INSTALLATION BULLETIN

2005 – 2006 Infiniti G35 Sedan

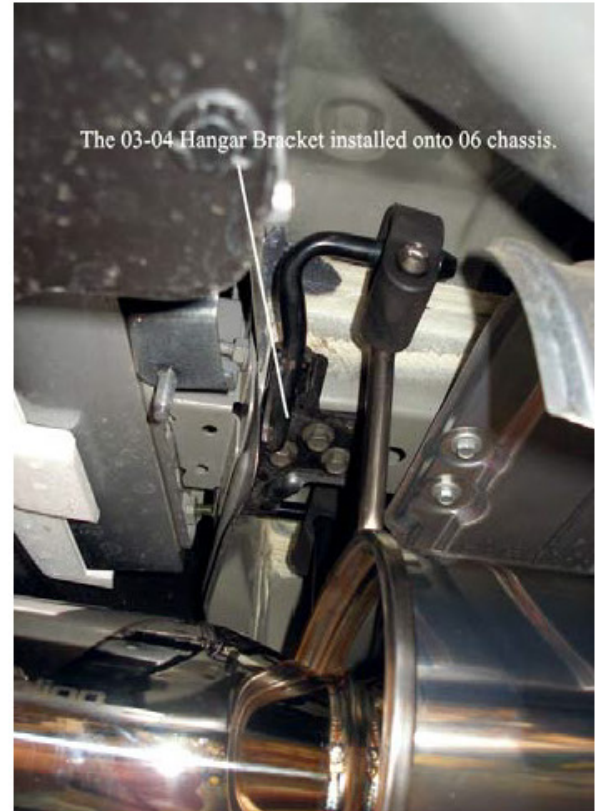
Due to changes in the design of the factory muffler on the 2005–2006 model year Infiniti G35 Sedan, a different type of exhaust mounting bracket is used that differs from 2003–2004 model year vehicles.

The 2005–2006 model G35 Sedans have carryover exhaust mounting provisions from the 2003–2004 model located on the chassis to accept installation of 2003–2004 mufflers and proper installation of the Tanabe Medalion Touring exhaust system, part number T70082.

Installation of T70082 on 2005–2006 Models will require the purchase of Infiniti OEM equipment for proper mounting.

The 03-04 Hangar Bracket installed onto 06 chassis.

The 05-06 model has provisions for the 03-04 bracketry.

The 06 Hangar Bracket, which sits above right on the canister

The 03-04 Hangar Bracket, which sits above the center of the canister

- x1 · **20742 AF400** · 03–04 G35 Sedan muffler mounting assembly
- x2 · **20651 AF400** · 03–04 G35 Sedan exhaust hangar bushing
- x3 · **08146 8252G** · Bolt

Tanabe Medalion Touring, Part number T70082 is designed for installation with the 2003–2004 Infiniti G35 Sedan hangar bracket. 2005–2006 Infiniti G35 Sedans will require the purchase of the 2003–2004 exhaust mounting assembly, shown above.
